# Intel® Xeon™ MP Processor

## Specification Update

*October 2003*

Document Number: 290741-021

### O1: BR0# Maximum Hold Time Specification Change

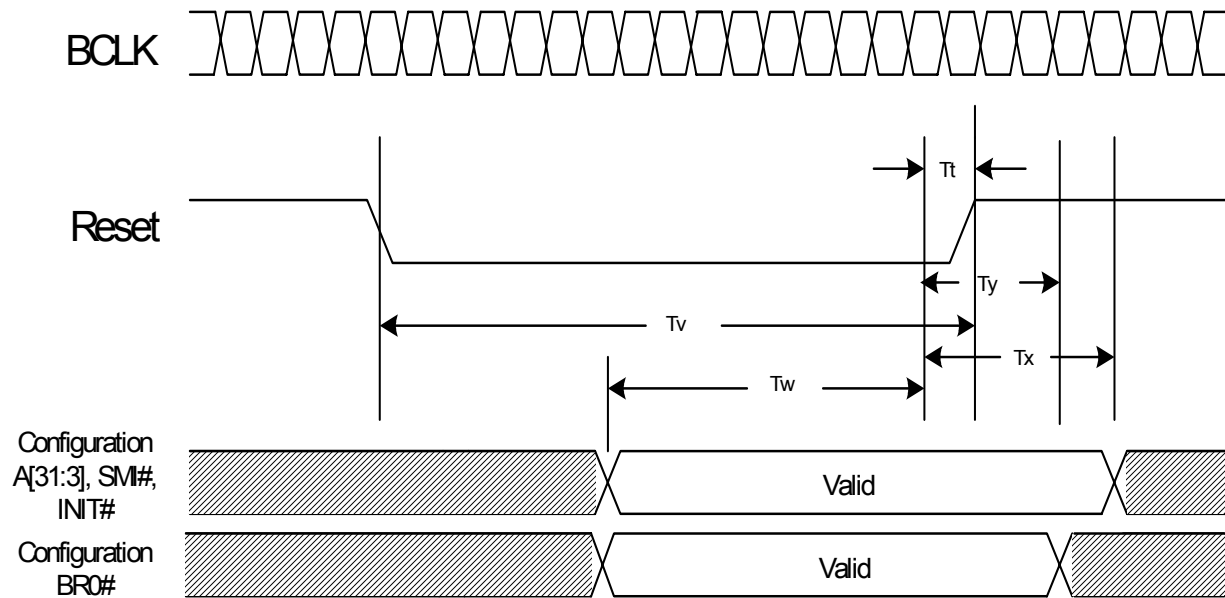
The BR0# maximum hold time has changed to 2 BCLKs. This change will be shown in the "System Bus AC Specifications (Reset Conditions)" table and "System Bus Reset and Configuration Timings" figure of the above mentioned datasheets. This change will be incorporated in the next revision of the above datasheets.

Signals (A[31:3]#, INIT#, SMI#) Hold Time					
T47: Reset Configuration Signal BR0# Hold Time	2	2	BCLKs	12	2

The following figure will be modified to reflect this change:
